Wireless IoT Modules Errata for RS9116x and RS14100 Products

This document contains information on the errata for all Silicon Labs Wireless module markings for RS9116x and RS14100 products. The errata describe the differences of the product datasheets and actual markings of the modules for Tracecode and 2D barcode in the modules.

The errata effective date: November 29th, 2021, for following products and its variants:

RS9116, RS14100

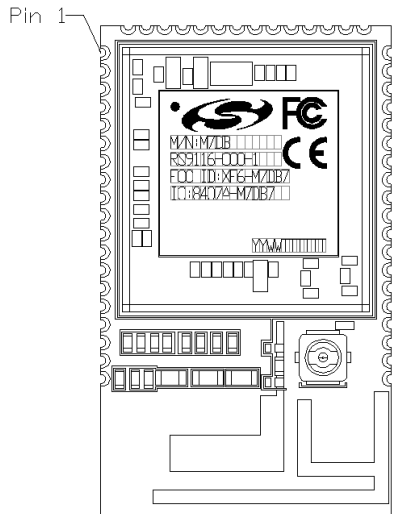
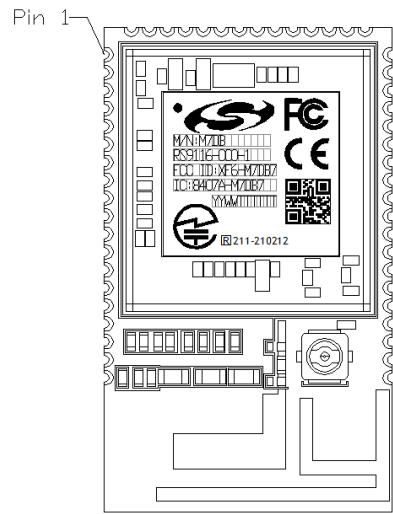
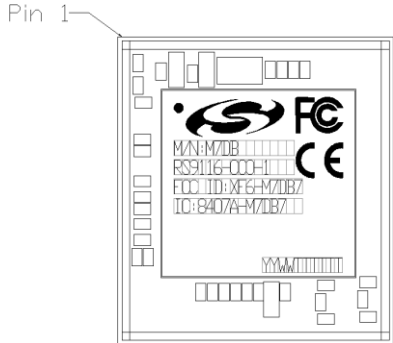
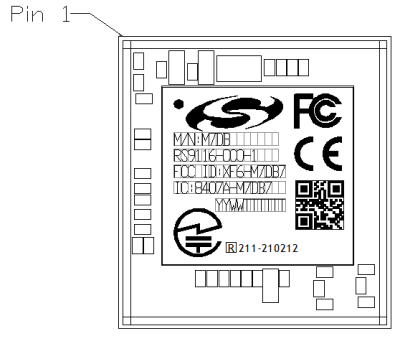
| Package Type | Revision | Current Marking | New Marking |
|----------------------------|----------|---|---|
| RS9116-M15SBB-XXX (AA0) | 1.3 |  |  |
| RS9116-M15SBB-XXX (AA1) | 1.3 |  |  |
| RS14100-A7-M7DB7-XXX (CC1) | 1.4 |  |  |
| RS9116-A7-M7DB7-XXX (CC1) | 1.4 |  |  |
